PARTS & SERVICE NEWS

REF NO.	AA00050
DATE	July 21, 2000

SUBJECT: IMPROVED COOLING HOSE ROUTING (CHAMFER ADDED TO HOOD,
NEW MOUNTING BRACKET FOR COOLING HOSE)

APPLICATION: WA450-3L Wheel Loader, S/N A30001 and up

RADIATOR PIPING (COOLING)

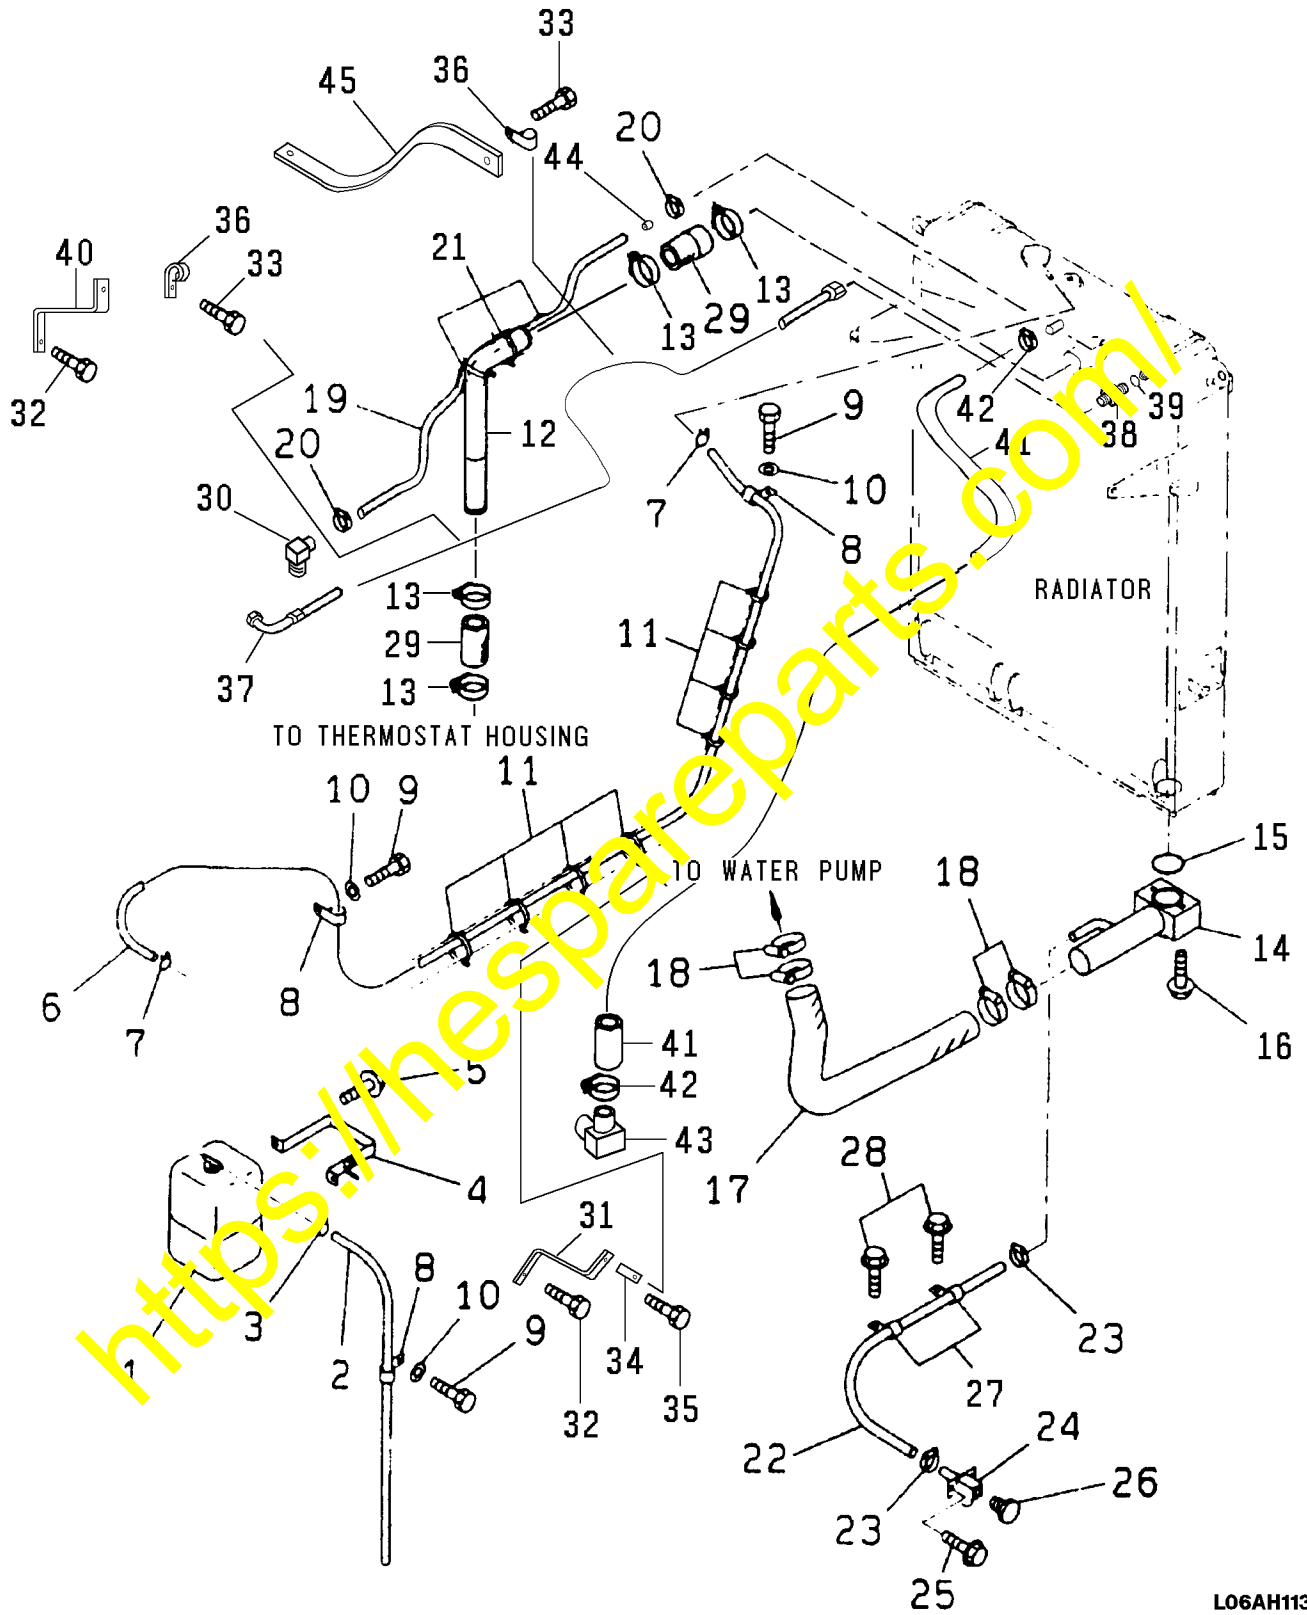
Reason for this change is to eliminate possible interference between radiator hose and hood components.

Part Number for the support hose has been changed to 421-03-A1320 (30)
